HOLLADAY SUBDIVISION

APPLICATION NUMBER 2 DATE March 1, 2007

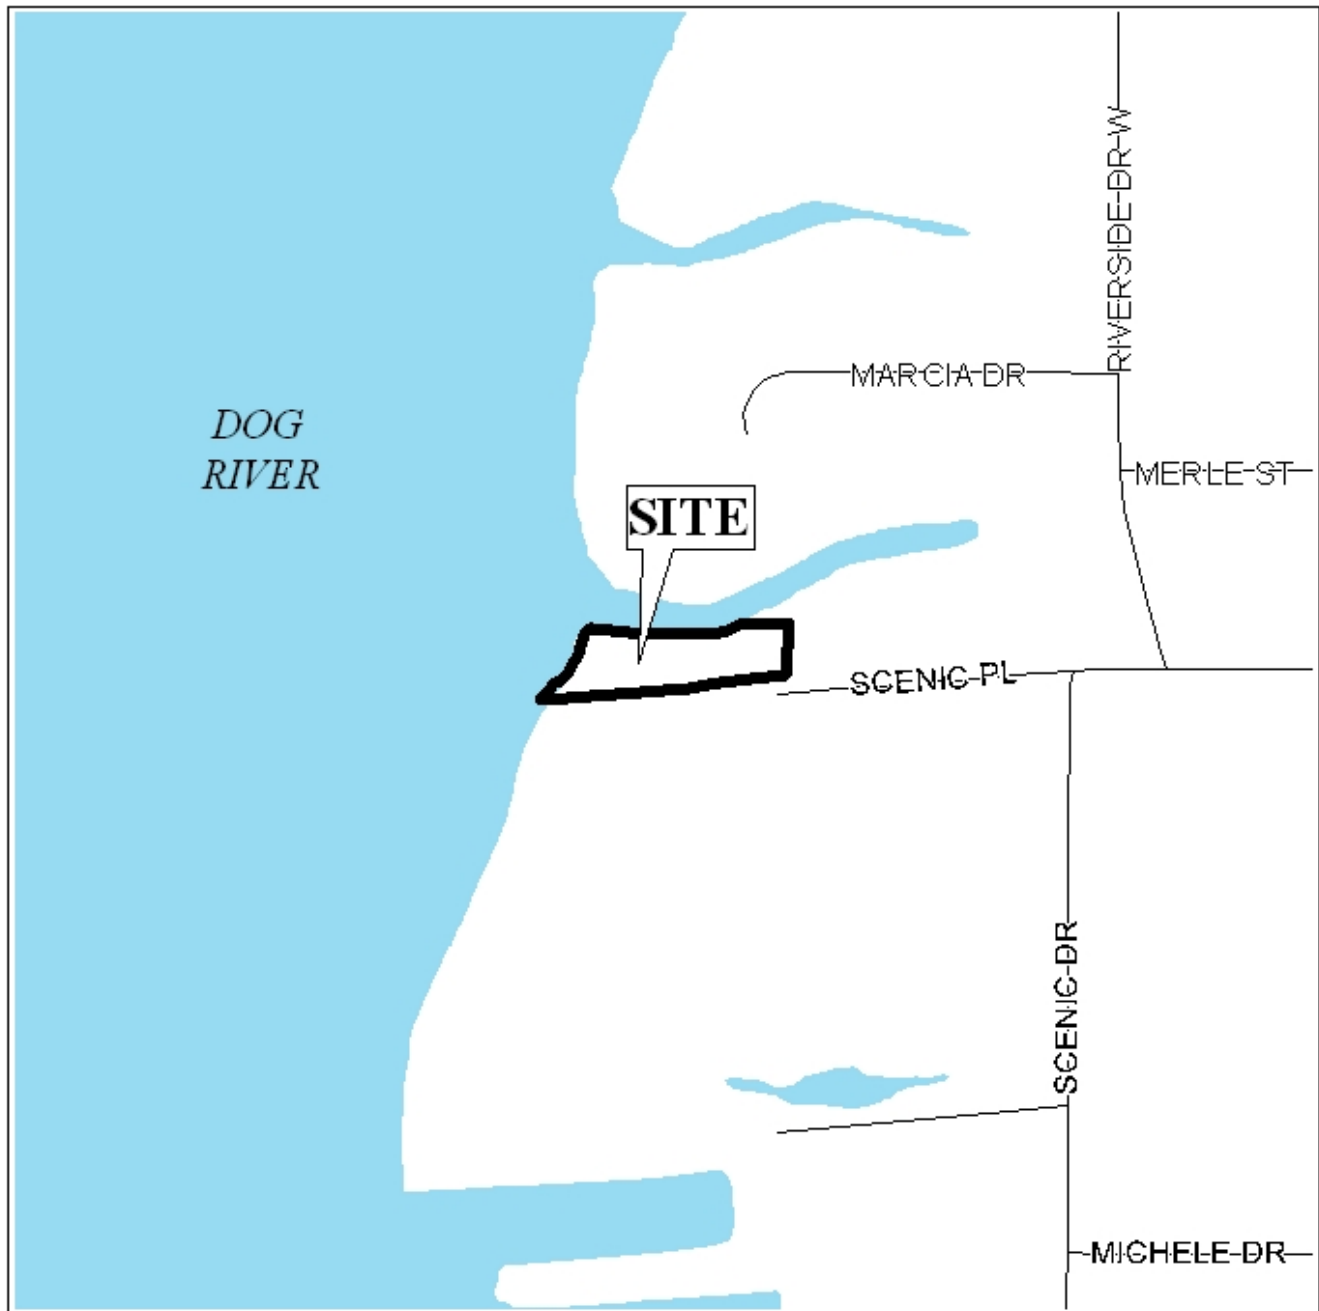
As illustrated on the plat, the right-of-way for Scenic Place is 30'. The standard right-of-way for a minor residential street is 50'. Therefore, dedication of sufficient right-of-way to provide 25' from centerline is required. Additionally, the improvements for Scenic Place are substandard. While it has been the practice of the Commission to not approve subdivisions on a street with substandard improvements, Scenic Place is maintained by the City of Mobile. The parcel in question has existed in this configuration for over 30 years and was occupied by a residential structure.

The site is adjacent to The Dog River and canal off the river, and as such would be considered environmentally sensitive. Therefore a condition of approval should be the placement of a note on the final plat stating the approvals from all applicable federal, state and local agencies shall be obtained prior to the issuance of any permits.

The site exceeds the width to depth ratio as recommended in Section V.D.3 of the Subdivision Regulations. However, given the configuration of the property, the fact that it has been in existence in this configuration for over 30 years, and this configuration is typical of other waterfront properties in the area; a waiver of Section V.D.3. would be appropriate.

The 25' minimum building setback line not shown, but will be required on the final plat, if approved.

Based on the preceding, it is recommended that Section V.D.3 be waived and the plat granted Tentative Approval, subject to the following conditions:

- 1) dedication of sufficient right-of-way to provide a minimum of 25' from centerline of Scenic Place;
- 2) revision of the plat to depict the 25-foot minimum building setback from Scenic Place labeling of the lot with its size in square feet, or provision of a table on the plat with the same information;
- 3) placement of a note on the final plat stating that approvals from all applicable federal, state and local agencies shall be obtained prior to the issuance of permits.
